From: Melton, Mark (ECY)
Sent: Tuesday, November 7, 2023 4:53 PM
To: Greg Steindorf
Cc: Heye, Amanda (ECY)
Subject: RE: Wetland Mitigation Downstream Distance

Thanks for the email. I will forward your comments to Amanda Heye to include with the formal comments on the draft 2024 SWMMWW.

Thank you for meeting with us to discuss the wetland protection requirements in the SWMMWW, I really appreciate you taking time out of your day for us. Below are the questions/comments we discussed in our meeting regarding the draft 2024 manual. I am curious how the questions/comments relate to the 2019 manual. The City of Ferndale will not adopt the 2024 manual until 2027 so we have a few more years of utilizing the 2019 and want to make sure we are applying that correctly to all engineers who have to incorporate wetland protection into their mitigation.

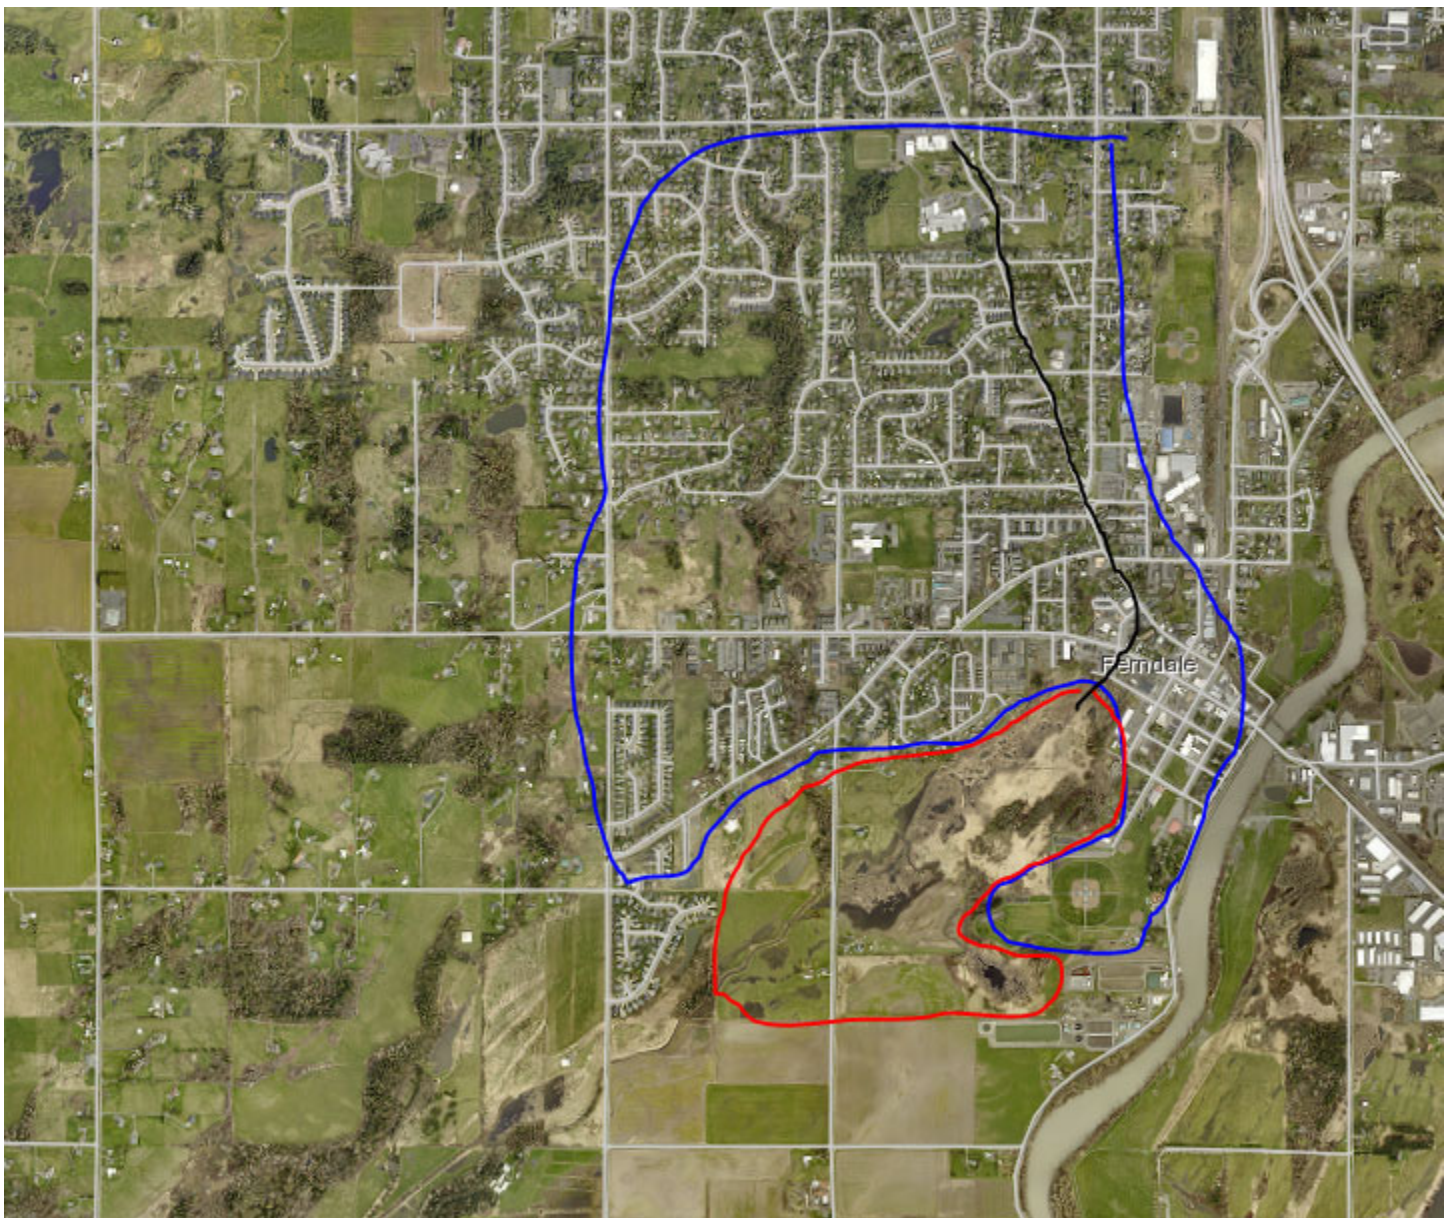
I do most of the stormwater review for the private developments in Ferndale so I am anticipating I will run into this several times. In the image below, the approximate wetland boundary is circled in red, the approximate contributing basin is circled in blue, and the black line is a flow path to the wetland that is approximately 1.2 miles long. I am not looking for site specific design guidance but considering the size of the contributing basin and the potential for numerous projects that currently contribute to the wetland, I would like to know what Ecology's opinion is on how detailed a small or large project in this area needs to get to address their potential wetland impacts? The City (Paul Cc'd here) and I are wanting to provide consistent guidance to all design engineers that may submit a project within this large contributing basin and we want to make sure we are following the manual as Ecology is intending for this requirement.

For the distance question you asked about, the answer comes from determining what the receiving water is. In the scenario that you provided if the 1.2 mile flow path is conveyance piping that outfalls at a wetland then MR8 would apply. If the 1.2 mile flow path is actually a river then the project would be outfalling to the river

and that would be the receiving water, not the wetland. In other words there is not a cutoff distance if the wetland is determined to be the receiving water.

For the question about modeling the 50 flow control BMPs. Our expectation is that the modeling for the flow control BMPs is focused on the BMPs within the project area not the entire contributing basin.
